## Product Change Notification

MULTIFUSE® PPTC RESETTABLE FUSES

### Reel Change for Select Bourns® Multifuse® PPTC Resettable Fuse Model Families

*MF-FSMF, MF-PSMF, MF-PSML, MF-PSHT, MF-NSMF, MF-NSHT, MF-USMF and MF-USHT*

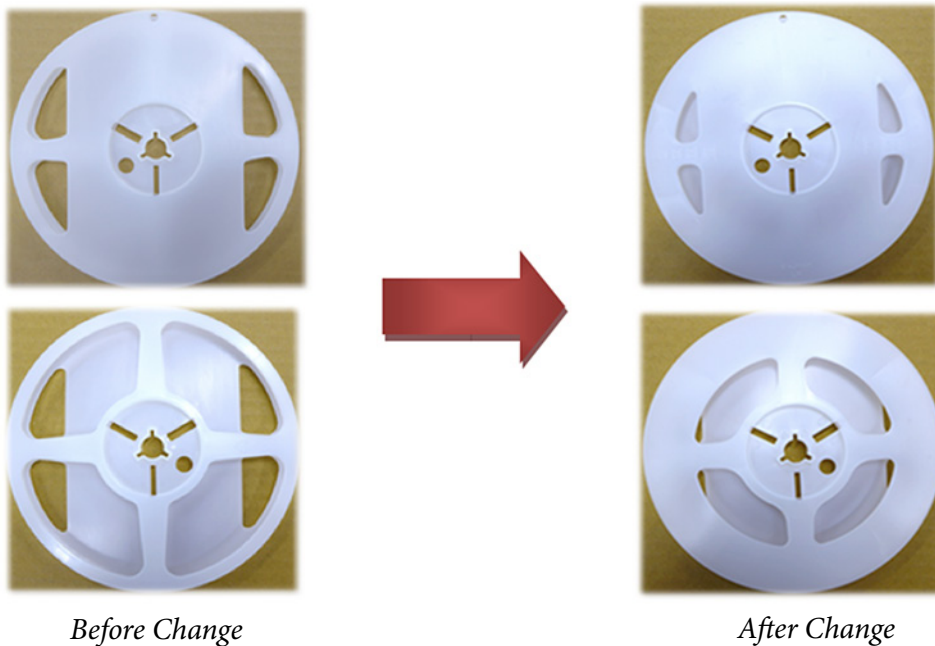
To improve the protection of Multifuse® products during packaging, transit and delivery, Bourns has decided to change the reel structure for model families, [MF-FSMF](#), [MF-PSMF](#), [MF-PSML](#), [MF-PSHT](#), [MF-NSMF](#), [MF-NSHT](#), [MF-USMF](#) and [MF-USHT](#) from a reel with significant hollow areas to a reel with a more solid structure. The radius, diameter, and width dimensions of the reel will not change. The new reel's more solid structure helps to increase its strength and improve its ability to withstand bending or warping when multiple reels are stacked on top of one another.

The change to the reels does not alter the form, fit, function, quality, or reliability of the Multifuse® PPTC Resettable Fuse products themselves. The complete list of affected part numbers for this reel change is included on the following page.

Implementation of this reel change will be on a running basis beginning: **November 1, 2017**
